Limited Visual Dam Safety Inspection Summary Report

MA-082

HC&S Reservoir 70

May 2006

082 crest

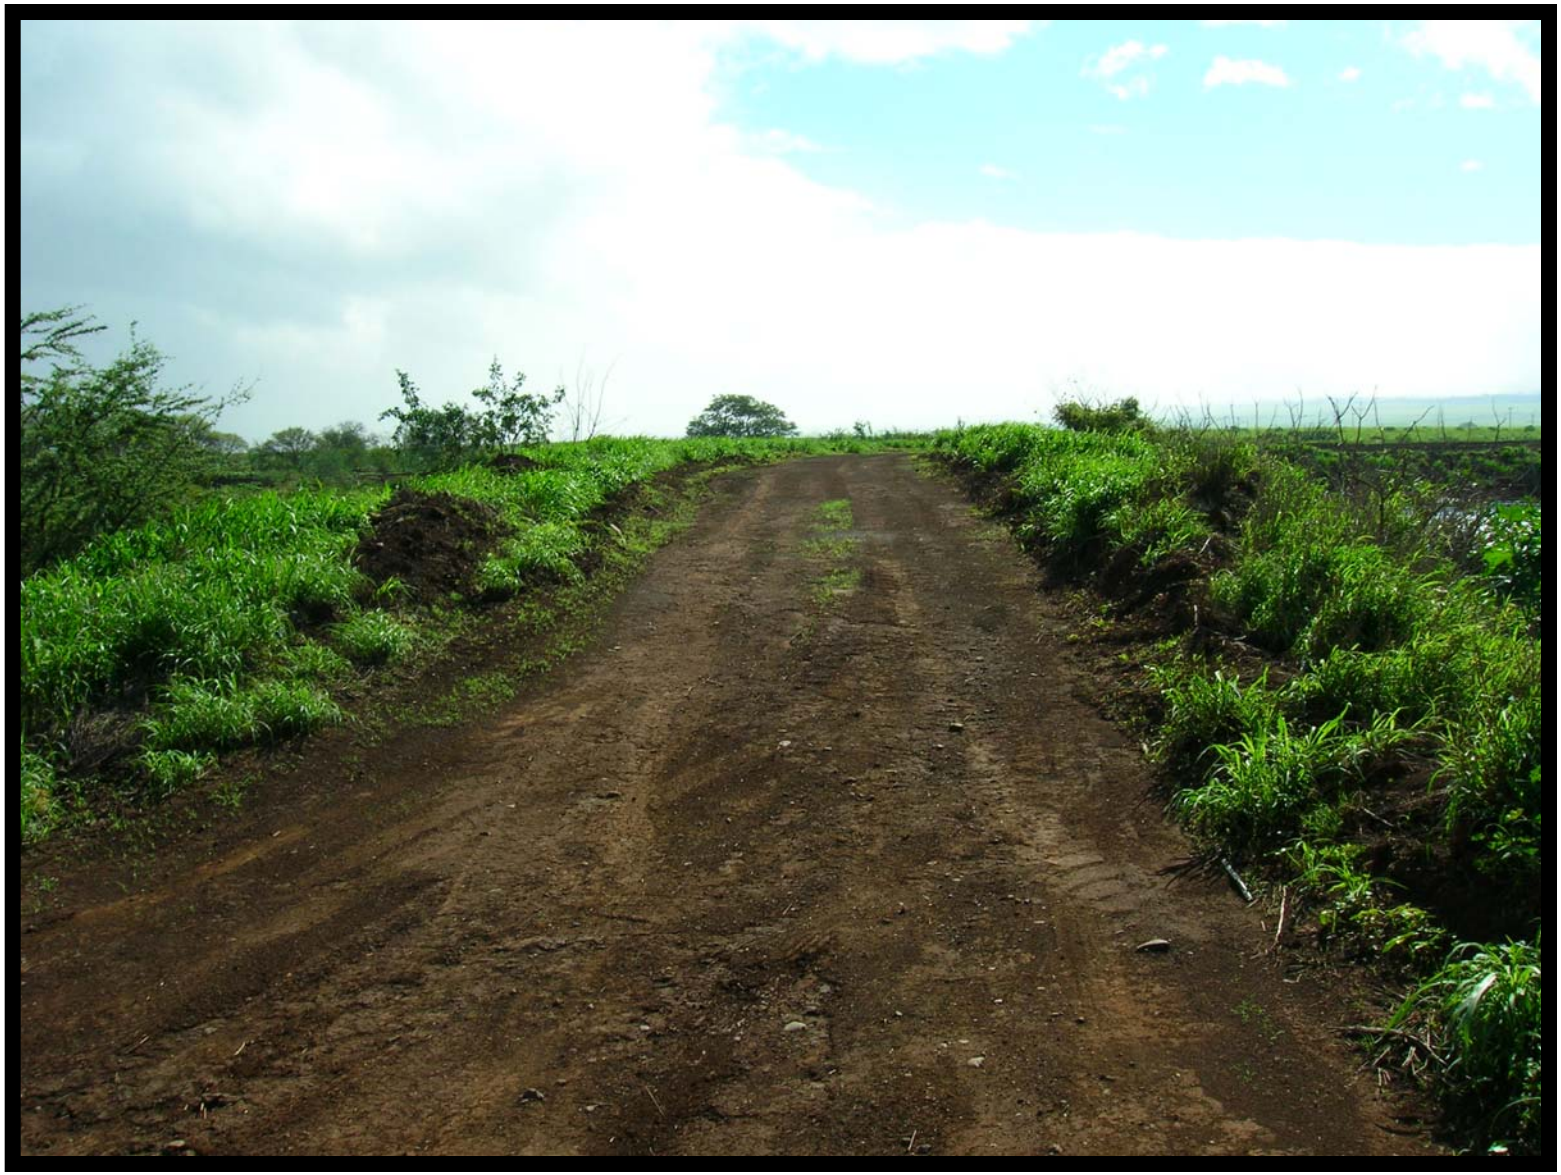
The dam crest was approximately 20 feet wide.
There was a roadway on the crest.
Erosion, cracks and sinkholes were not observed.

a. The dam crest appeared to be in satisfactory condition, no corrective actions are required at this time.

082 downstream toe scarp

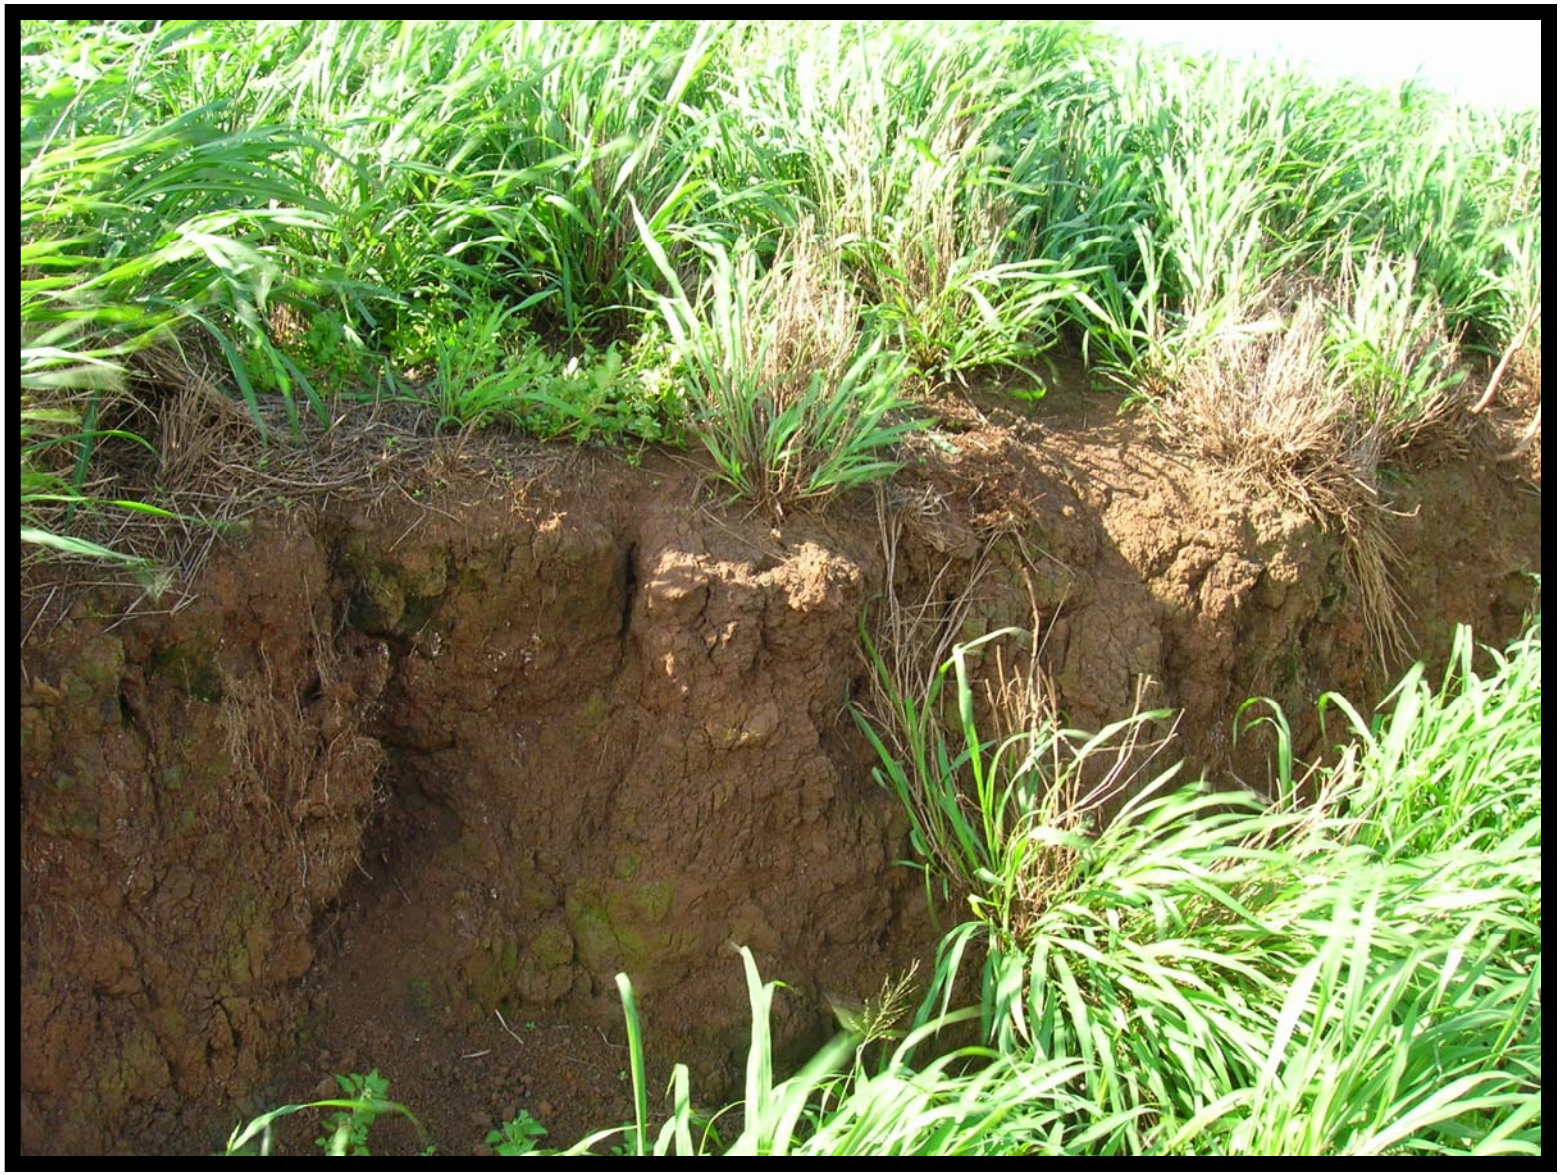
a. The downstream slope appeared to be in fair to poor condition and requires corrective action.
b. The down stream slope was not visible due to high grass and bush vegetation. Clear high vegetation and maintain low to enable easy visual inspection.

c. Tree(s) were observed on the downstream slope. Trees have been identified as the probably cause of piping failures, and can possibly cause sever damage to the embankment if they are uprooted during a high winds. Corrective action is required to remove the tree hazards from the dam. Acceptable remedies include removal of the tree and its root structure down to a 2" diameter and reconstructing the damaged embankment section. All repair work shall be accomplished as per the requirements of licensed geotechnical or structural engineer. Routinely monitor the damaged area for signs of settlement and seepage.

d. The slope was very steep, around a 1 to 1 slope; further study is required to verify slope stability.

082 spillway 3

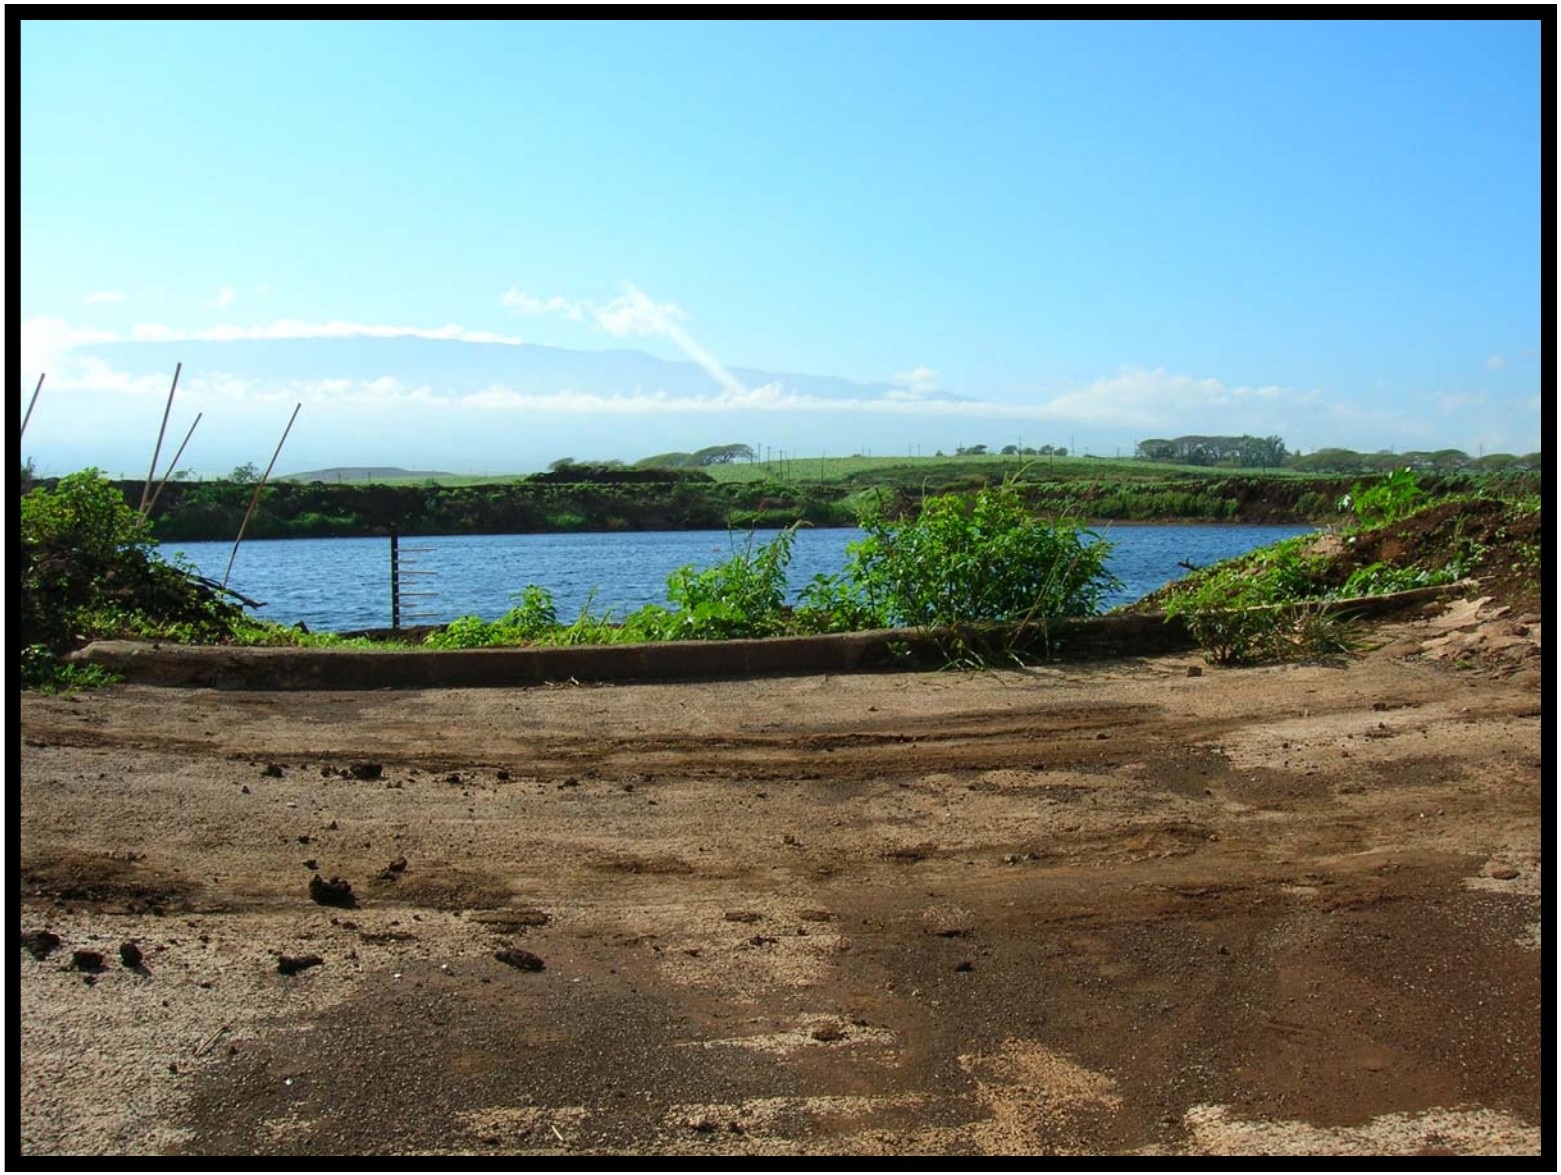
This spillway consisted of a 20 ft wide by 2.5 ft deep channel.
The spillway approach was clear.
There was no erosion observed near the spillway.
Further investigations should be conducted to conclude the capacity of the spillway.

a. The spillway appeared to be in fair to poor condition and requires corrective action.
b. Unclear if spillway is adequately sized. Spillway should pass the probable maximum flood. Verify spillway capacity and take corrective action as required.
c. It appears flow could easily cross busy roads downstream of dam.

082 upstream slope

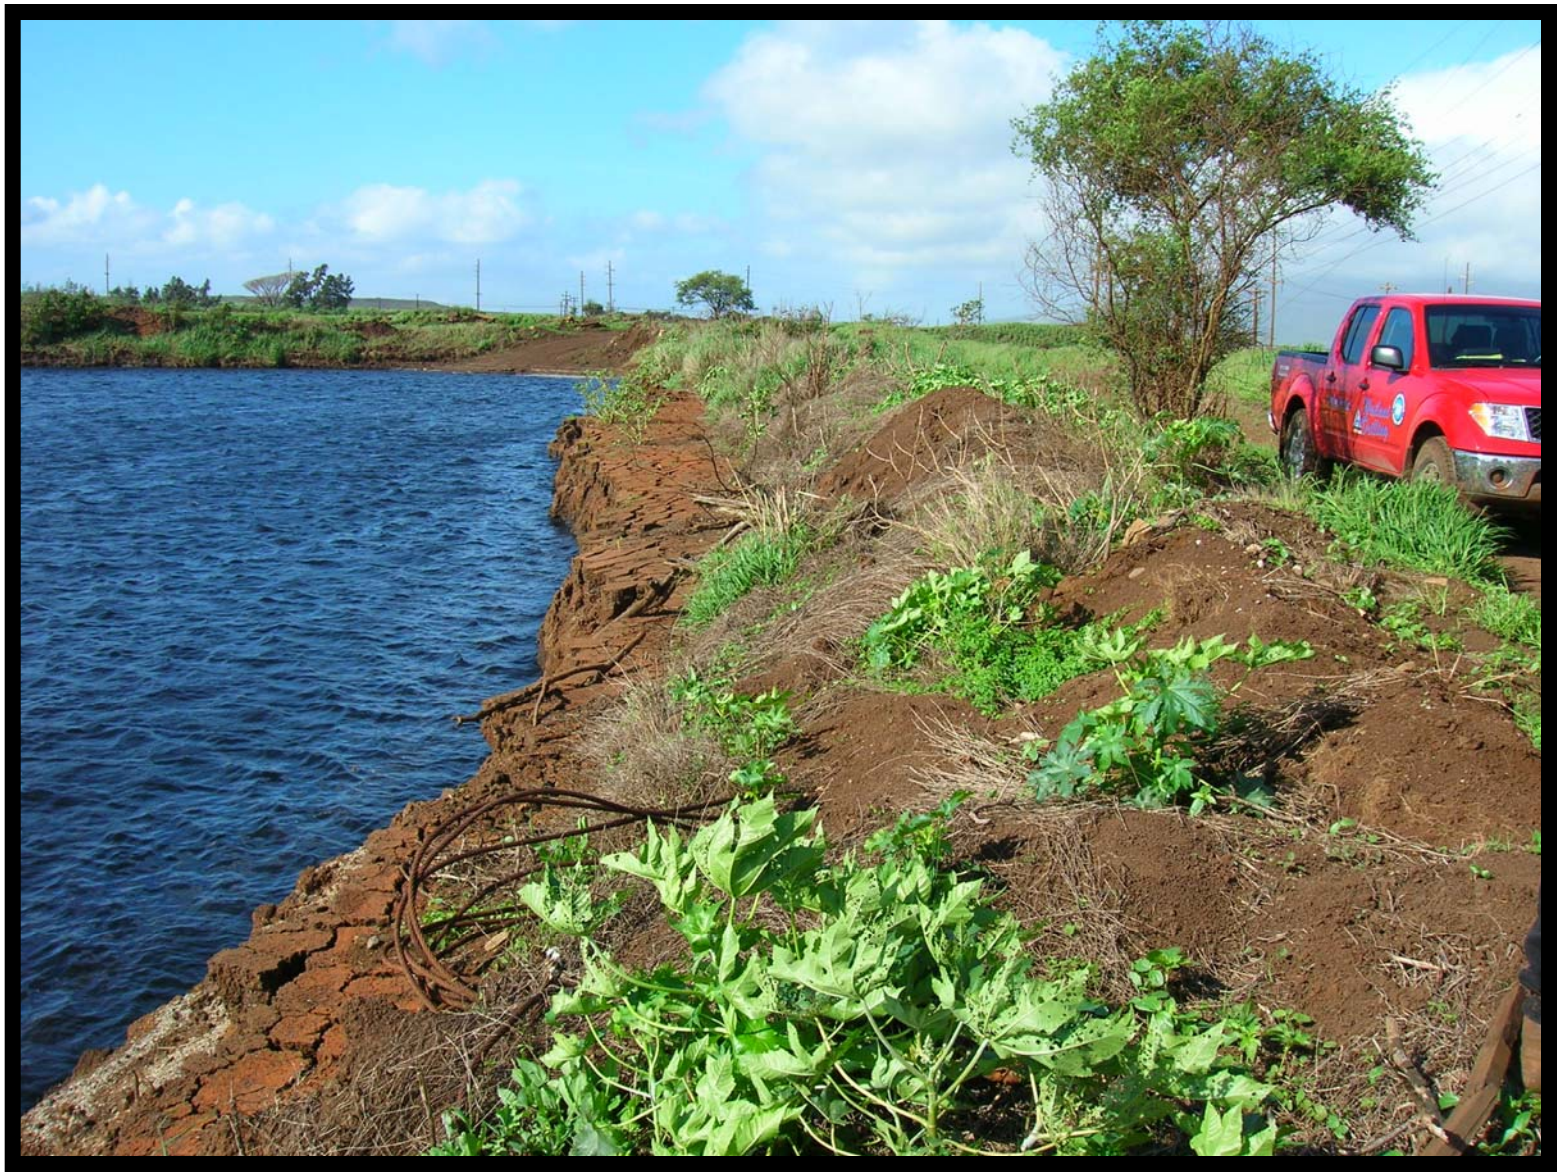
The upstream slope varied in slope and ranged from a 1 on 2 slope.
No slope protection was observed.
Erosion was not observed, the slope was not entirely visible.
Cracks were not visible; the slope was not entirely visible.
Sinkholes were not visible; the slope was not entirely visible.

a. The upstream slope appeared to be in fair to poor condition and requires corrective action.
b. The upstream slope was not visible due to high grass and bush vegetation. Clear high vegetation and maintain low to enable easy visual inspection.
c. Tree(s) were observed on the dam embankment. Trees have been identified as the probably cause of piping failures, and can possibly cause sever damage to the embankment if they are uprooted during a high winds. Corrective action is required to remove the tree hazards from the dam. Acceptable remedies include removal of the tree and its root structure down to a 2" diameter and reconstructing the damaged embankment section. All repair work shall be accomplished as per the requirements of licensed geotechnical or structural engineer. Routinely monitor the damaged area for signs of settlement and seepage.
